SERVICE INFORMATION BULLETIN

APPLICABILITY: 2016-2018MY Forester
 2015-2016MY Impreza 2.0L
 2015-2017MY Crosstrek

NUMBER: 04-20-18

SUBJECT: Steering Angle Sensor- Part Change Information

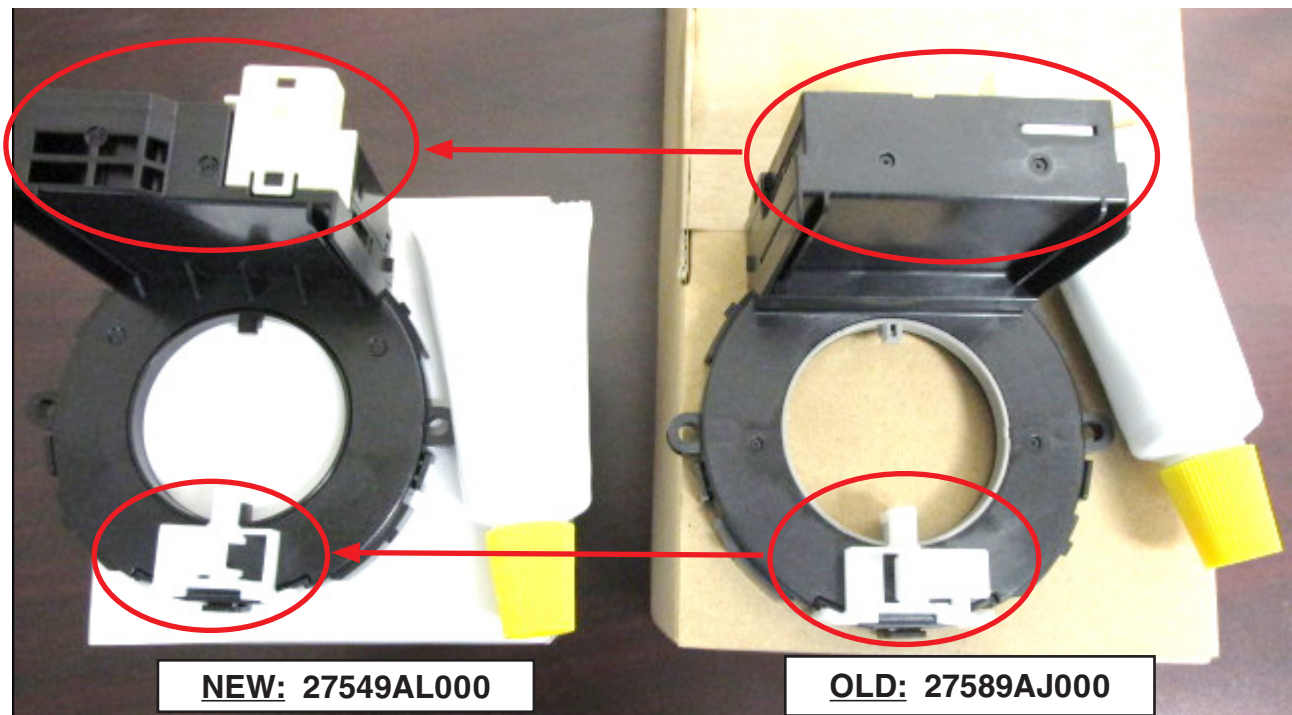
This Service Information bulletin announces a running change made to the Steering Angle Sensor. The (new) -style originally used on Legacy and Outback has been adapted for use on the additional models listed above.

The photos below show the most easily identifiable features to the Steering Angle Sensor to help differentiate between the old and new-style parts.

IMPORTANT: When Sensor replacement is necessary on a model applicable to this bulletin, always replace the old part with the same style as originally equipped. Once inventory of the old-style part has been exhausted, the old part number, 27589AJ000 will be superseded to 27549AL000.
